SITE PLAN FOR SUBDIVISION VISTA DEL NORTE AMENDMENT NO. 3 MARCH 23, 2001

REASON FOR AMMENDMENT NO. 3

PROJECT# 1000490
00411
APPLICATION# 00450-00000-0000 (DRB)
EPC 00110-00000-00590/00129-00000-00593

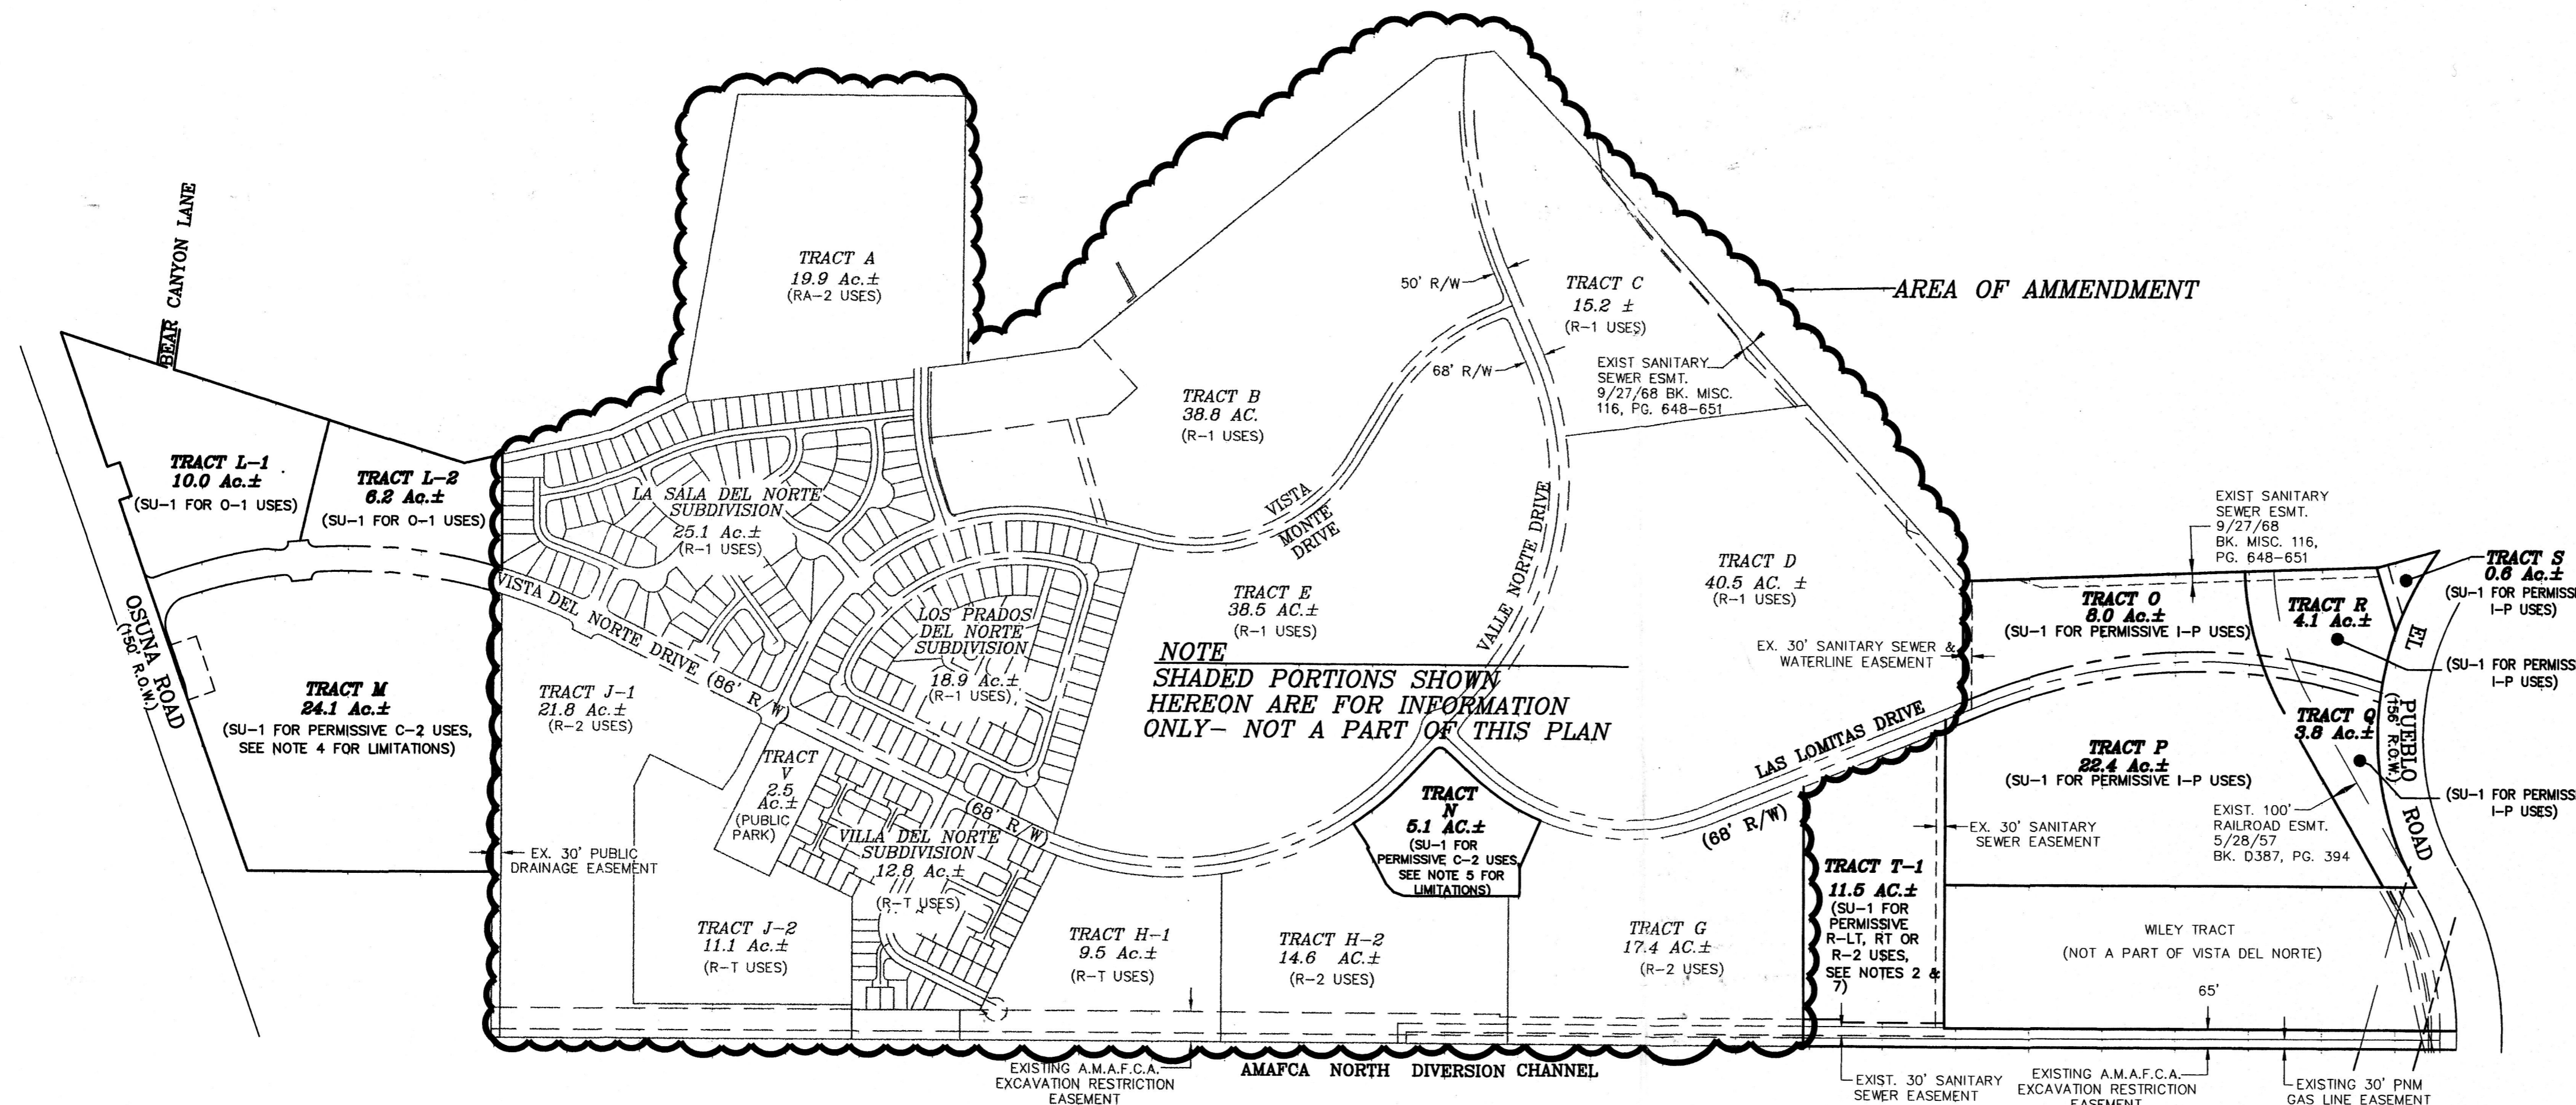
THIS AMENDMENT REMOVES ALL AREAS FROM THIS PLAN (SHADED) THAT WERE CHANGED TO STRAIGHT ZONING FROM SU-1 ZONING BY THE ENVIRONMENTAL COMMISSION ON JULY 20, 2000. STRAIGHT-ZONED PORTIONS OF THIS AREA ARE NOT REQUIRED TO BE CONTROLLED BY A SITE DEVELOPMENT PLAN.
